# planning statement

Internal alterations, roof & rear extension at 6 Fortess Rd, NW5

**Tom Young Architects**

SEPTEMBER 2020

## View 1 of rear area

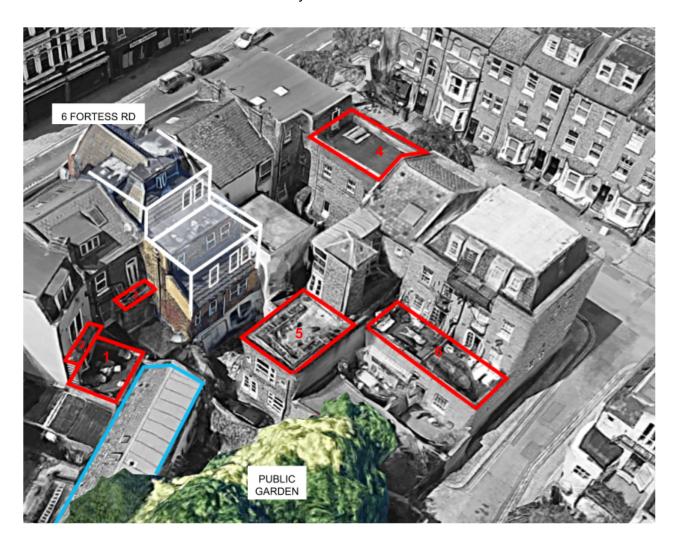
Upper floor extensions would have unacceptable impact to light and outlook on neighbouring properties – particularly to the north of the site

Camden remarks the proposals impact "light and outlook" particularly to the north of the host property. We cannot see the evidence.

There are existing external amenity areas (red-line) around 6 Fortess Rd at the rear. They are overlooked by upper floor accommodation openings in many buildings.

The upper floor accommodation at 6 Fortess Rd already overlooks outside amenity areas or terraces & balconies

The rear & roof extensions proposed do *not* compromise the redlined areas.
